Pacwest Center

Building *repositioning*

DESIGN ADVICE REVIEW
02.18.2016

FAR

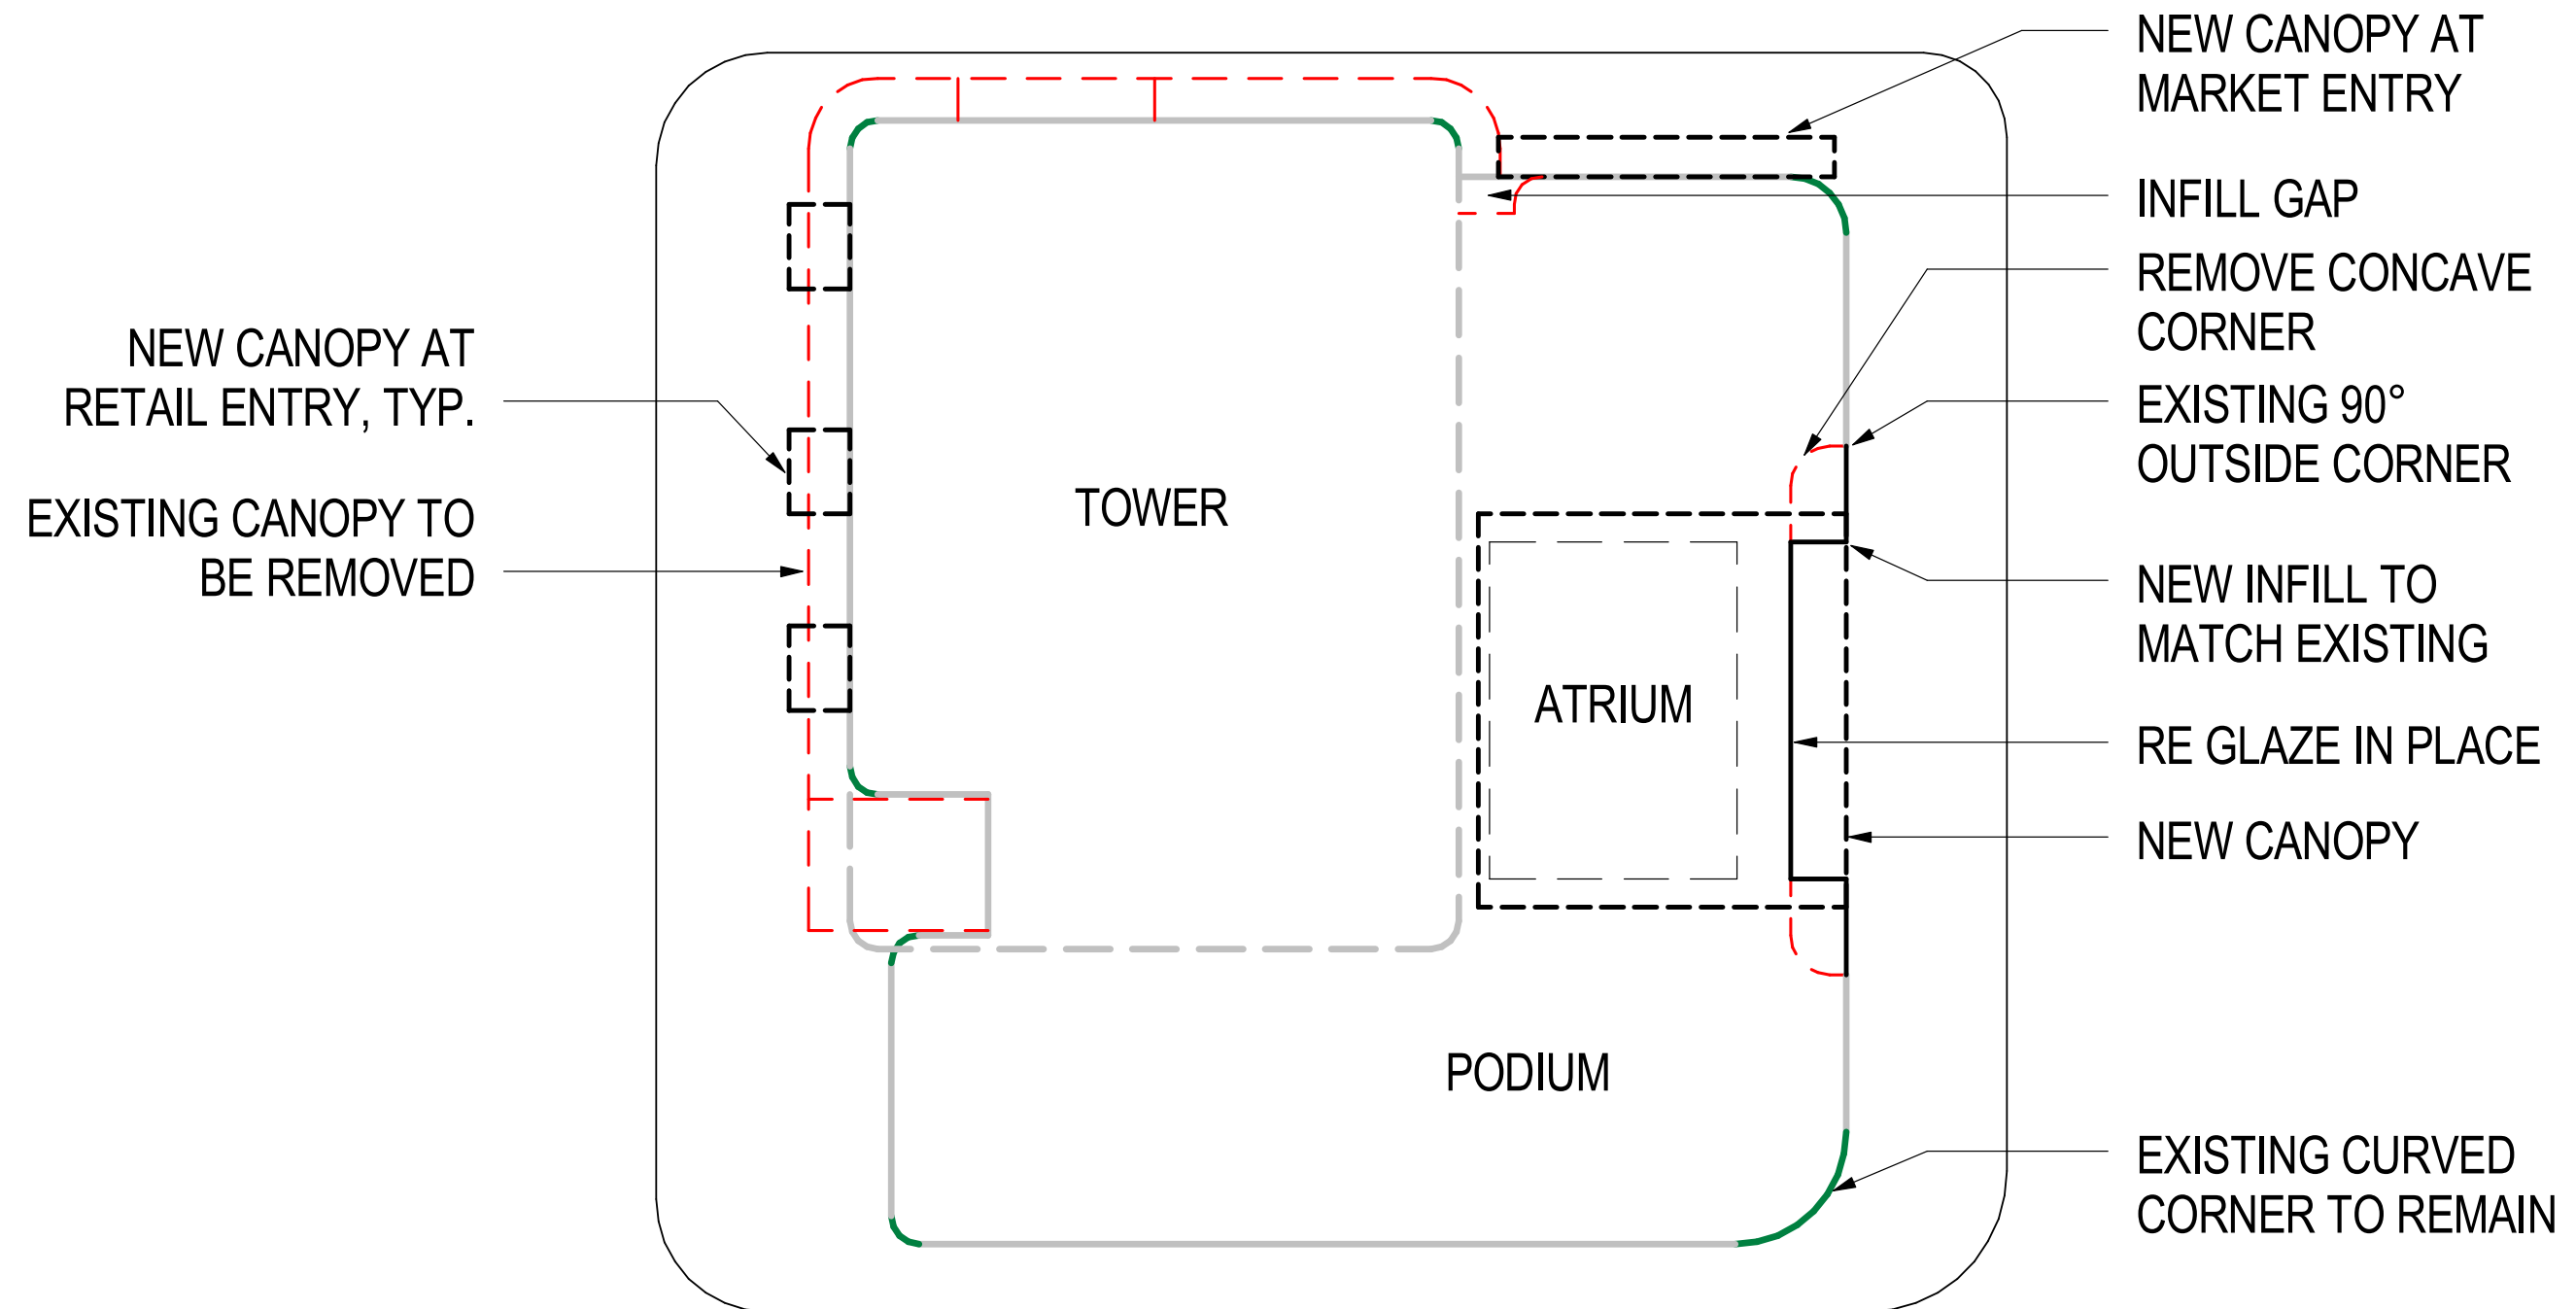
FAR. As noted at the Pre-Application Conference, the building appears to exceed the total approved FAR allowed for the property. The 1980 Ordinance No. 150773 approved a Variance, allowing an FAR of 14.2:1, more specifically described as 524,314 sf of office and 44,415 sf of retail, for a total of 568,729 sf. Staff notes that our records indicate a total of 596,161 sf of floor area, resulting a difference of 27,432 sf from that approved in 1980. The applicant must provide documentation – such as approved building permit drawings with approved floor area indicated – that the existing FAR has been approved by the City, or that our records are incorrect. Any newly proposed floor area will require the use of bonus or transfer floor area. Please see 33.510 and 33.130 for bonus and transfer options.

Based on our records, only 3,839 sf of additional floor area can be approved through the provision of bonus or transfer options to reach a maximum of 15:1 FAR; any more than that is prohibited. If the proposed FAR is to exceed 15:1, a Central City Master Plan will be required; please see 33.510.255 Central City Master Plans.

- No FAR calculation has been completed since the original building was calculated.
- Additional research is required, and/or new calculations must be completed to resolve discrepancies.
- Net added floor area is limited, and potential bonuses adequately cover the proposed added area.

Level 01	+1015 sf
Level 02	- 1000 sf
Level 03	+1775 sf
Net total	+ 1790 sf

ROOFTOP GARDEN
> 50% Total floor area is covered
> 30 % Contains plants

Potential bonus (1:1) = 14,226sf

LOCKER ROOM
New bicycle storage & Locker room (2,566sf)

Potential bonus (1:40) = 102,640sf

CURVED FORMS

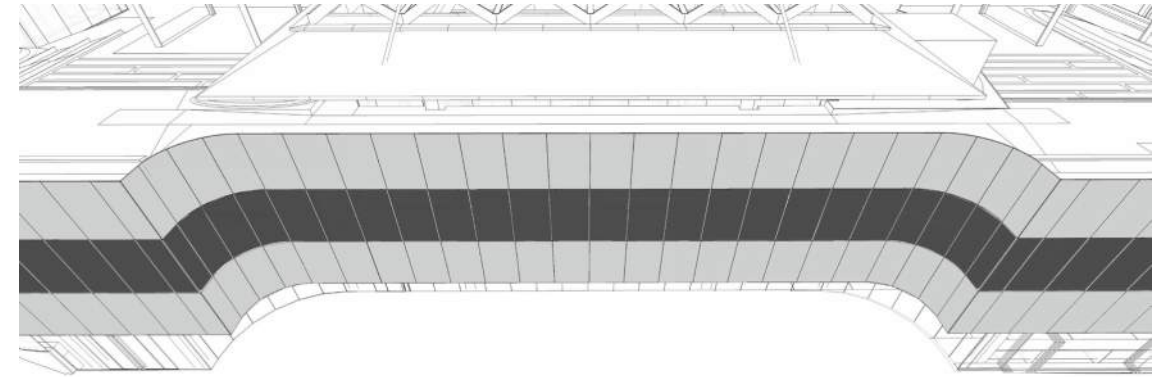
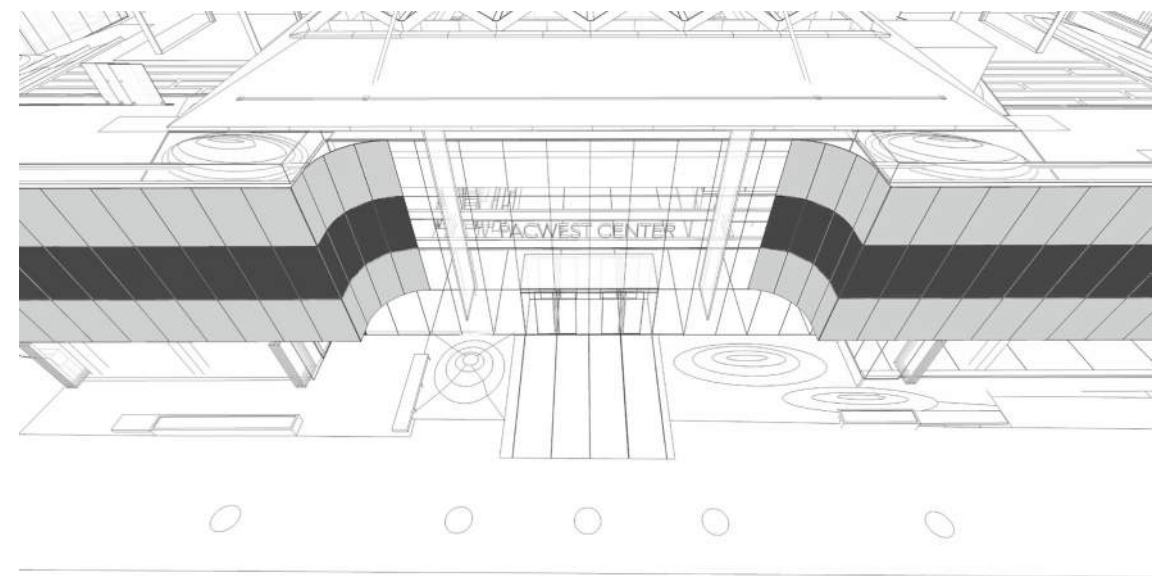
Curved Forms. Staff notes that the curved forms of the building are character-defining features of the existing building; therefore the removal of these curves – at the main 5th Avenue entrance, at the SW Jefferson egress stair, the 3rd and 4th floor enclosure, and at the ground level northeast corner tenant space – will be a discussion item at the Design Advice hearing scheduled for February 18th. Staff suggests retaining the exterior curved forms where possible. Staff is also concerned about how the newly enclosed portions of floor area will be treated at the exterior with regard to blending in with the existing building, e.g. how stem wall transitions will be treated, etc.

- Opaque façade – No perception of the interior atrium
- Concave curves are an anomaly on the building – 90 deg. Outside corners are existing
- Restricted circulation at the ground floor

- Large, transparent façade to connect exterior to interior atrium
- 90 deg. Outside corners match existing façade
- 90 deg. Inside corners allow for logical material transition
- Expanded retail frontage at ground floor

- 15' loss of transparent façade to accommodate curves
- Difficult material transition in the same plane

CURVED FORMS

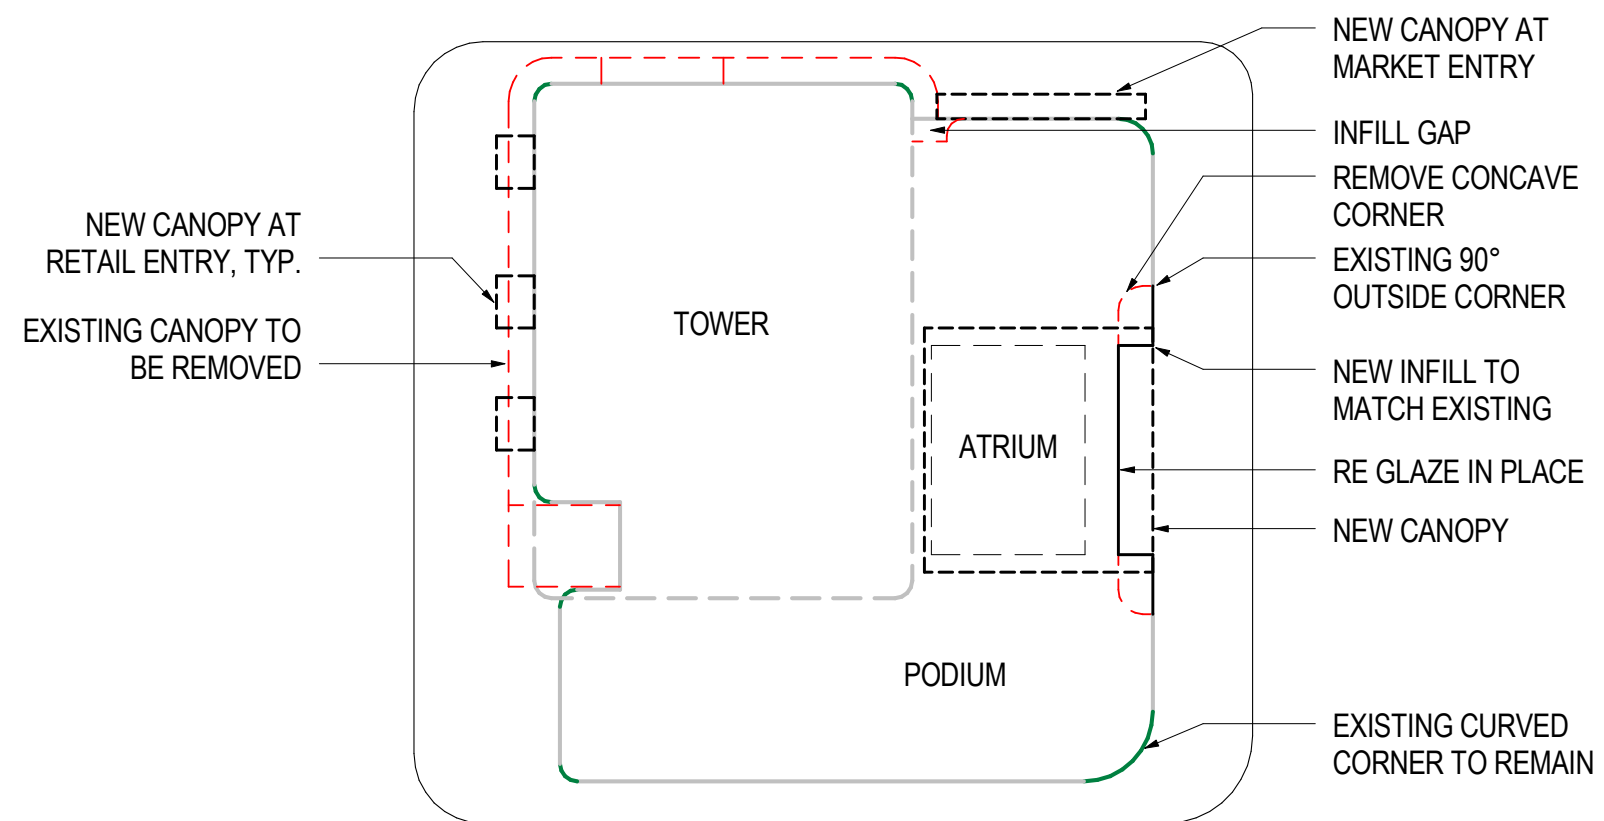
Curved Forms. Staff notes that the curved forms of the building are character-defining features of the existing building; therefore the removal of these curves – at the main 5th Avenue entrance, at the SW Jefferson egress stair, the 3rd and 4th floor enclosure, and at the ground level northeast corner tenant space – will be a discussion item at the Design Advice hearing scheduled for February 18th. Staff suggests retaining the exterior curved forms where possible. Staff is also concerned about how the newly enclosed portions of floor area will be treated at the exterior with regard to blending in with the existing building, e.g. how stem wall transitions will be treated, etc.

- Proposed 90 deg. Inside corners match SW 6th Ave entry
- Provides logical material transition
- Maximizes clear glass façade

CURVED FORMS

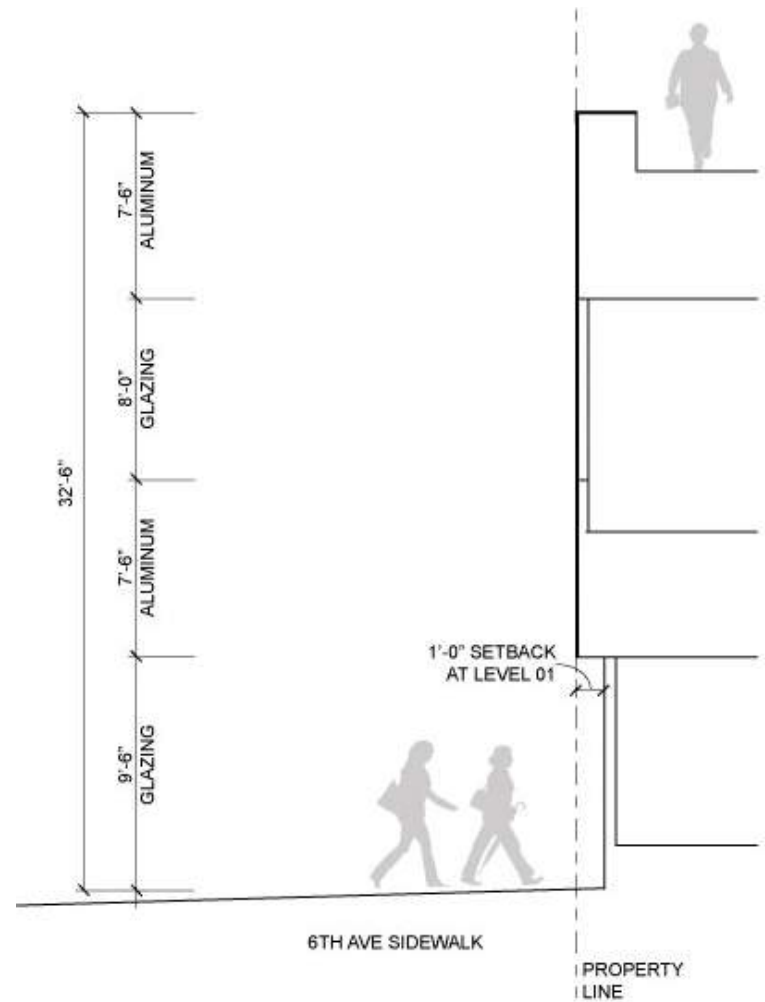
Curved Forms. Staff notes that the curved forms of the building are character-defining features of the existing building; therefore the removal of these curves – at the main 5th Avenue entrance, at the SW Jefferson egress stair, the 3rd and 4th floor enclosure, and at the ground level northeast corner tenant space – will be a discussion item at the Design Advice hearing scheduled for February 18th. Staff suggests retaining the exterior curved forms where possible. Staff is also concerned about how the newly enclosed portions of floor area will be treated at the exterior with regard to blending in with the existing building, e.g. how stem wall transitions will be treated, etc.

- Upper aluminum façade is the strong visual element at the NE corner
- Curved form above is dominant while the lower glass visually recedes
- Lower glass is set back 1', so faceted windows do not compete with the curved façade above

NE Corner Analysis

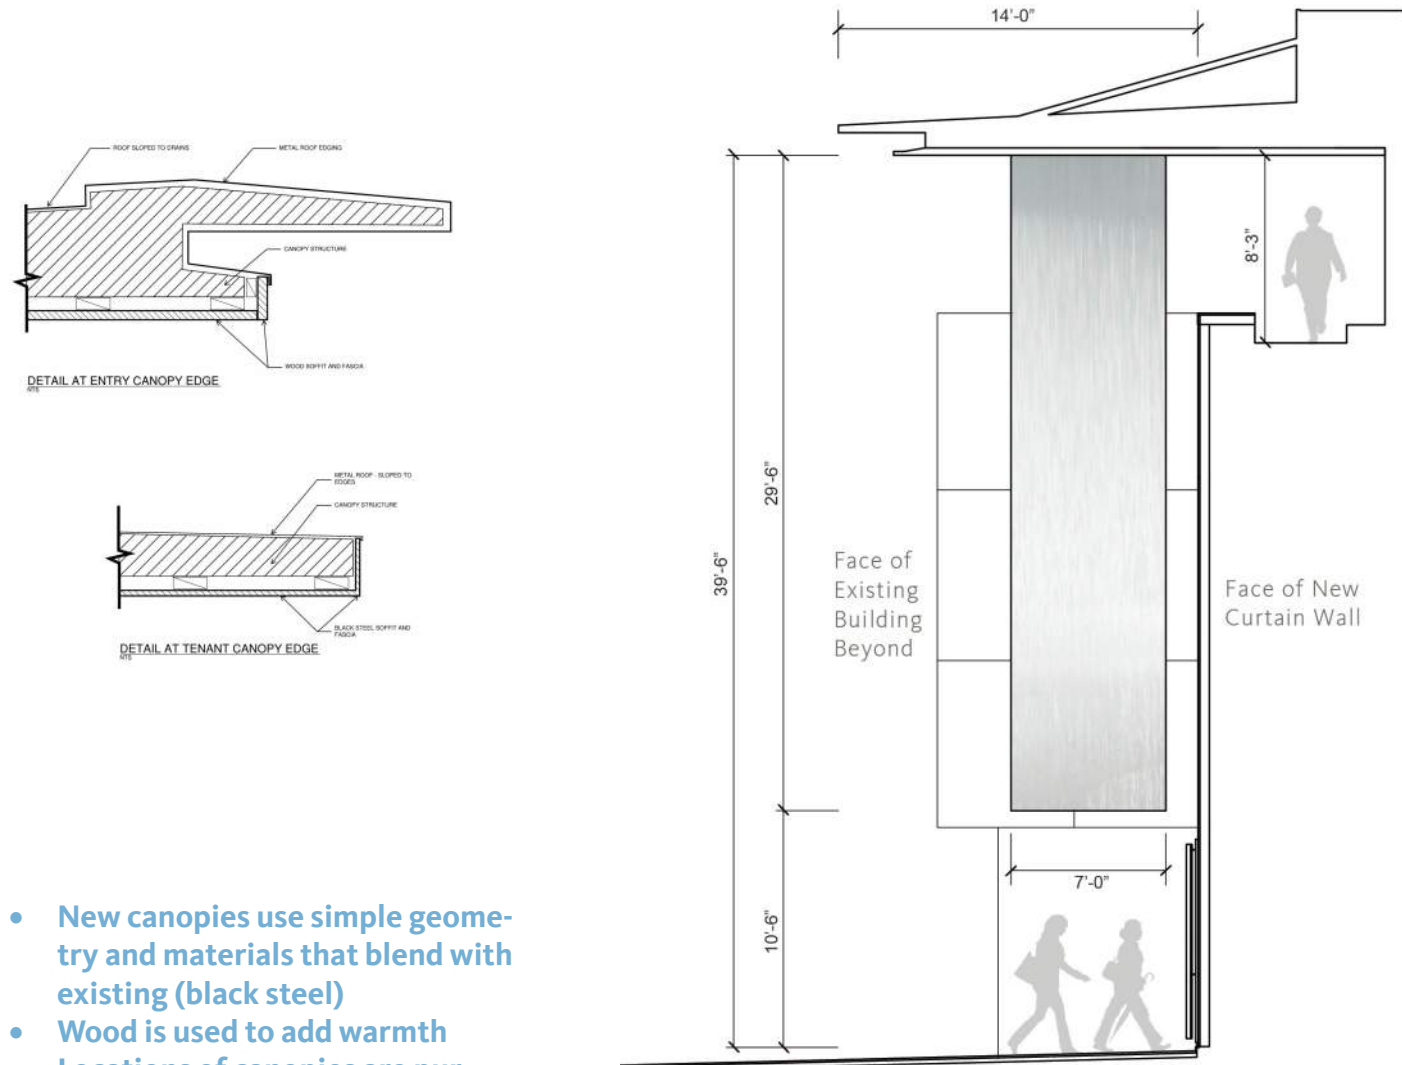
...While opening up the northeast corner will increase activation of that corner for a few months out of the year, staff has concerns about the loss of the dynamic quality of the existing curved wall. Staff notes that the glazing at this corner is curved rather than Segmented, as is proposed. As such, staff suggests additional consideration of how the Proposed treatment could be made more graceful and compatible with the existing building.

...While opening up the northeast corner will increase activation of that corner for a few months out of the year, staff has concerns about the loss of the dynamic quality of the existing curved wall. Staff notes that the glazing at this corner is curved rather than segmented, as is proposed. As such, staff suggests additional consideration of how the proposed treatment could be made more graceful and compatible with the existing building.

- Curved, operable windows are not manufactured
- Benefit of opening façade and providing direct connection to exterior outweighs closed system
- Sliding glass system will be minimal and not complete visually with the existing upper façade
